UNITED STATES PATENT AND TRADEMARK OFFICE

APPLICATION NO.	FILING DATE	FIRST NAMED INVENTOR	ATTORNEY DOCKET NO.	CONFIRMATION NO.
09/904,738	07/13/2001	Thomas W. Lenhart	500946	3368

Office Action Summary

DETAILED ACTION

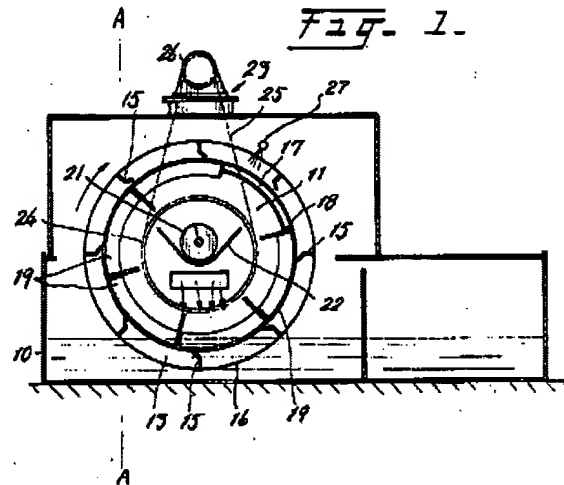
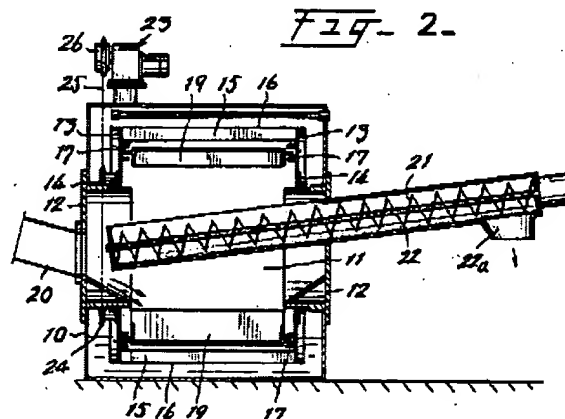
Claims 1-2,4-6,9-10, and 13-14 are rejected under 35 U.S.C. 102(b) as being anticipated by Uchiyama (US 4,724,077).

"The filtering apparatus of the present invention generally comprises a cutting oil collection tank 10 and a filtering drum 11 journalled on cylindrical bearings 12, 12 which are in turn secured to the opposite or right-hand and left-hand side walls of the tank 10. The drum 11 is in the form of a hollow cylinder which is defined by a pair of opposite and spaced apart annular plates 13, 13 each having an outwardly extending boss 14 on the inner periphery thereof by means of which the annular plate is rotatably supported on the associated cylindrical bearing 12 whereby the drum is supported in the tank for rotational movement relative to the latter. The drum 11 is supported in the cutting oil collection tank 10 such that a portion of the periphery of the drum is always immersed in the body of cutting oil held in the cutting oil collection tank." (Col. 2, lines 10-20)

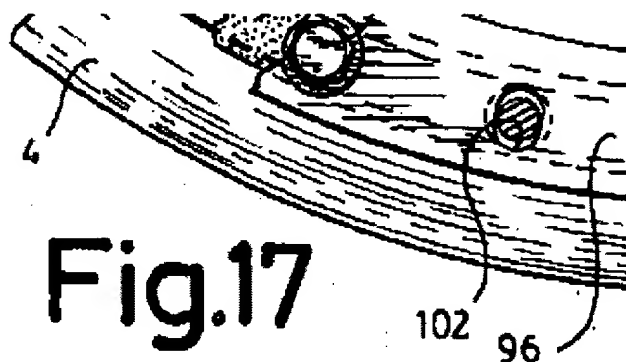
Claim 3 is rejected under 35 U.S.C. 103(a) as obvious over **Uchiyama (US 4,724,077)** and **Hannum (US 4,645,598)**.

Claim 3 specifies the pair of bearings to be polymer bearings. Uchiyama is silent with respect to this limitation, however, the use of polymer materials (i.e., plastic) is notoriously well known in the art. Exemplary of this is Hannum, who discloses the use of non-metallic materials in a similar apparatus:

In view of the Hannum disclosure, it would have been obvious to employ polymer bearings in the device of Uchiyama for the reasons advanced by Hannum.
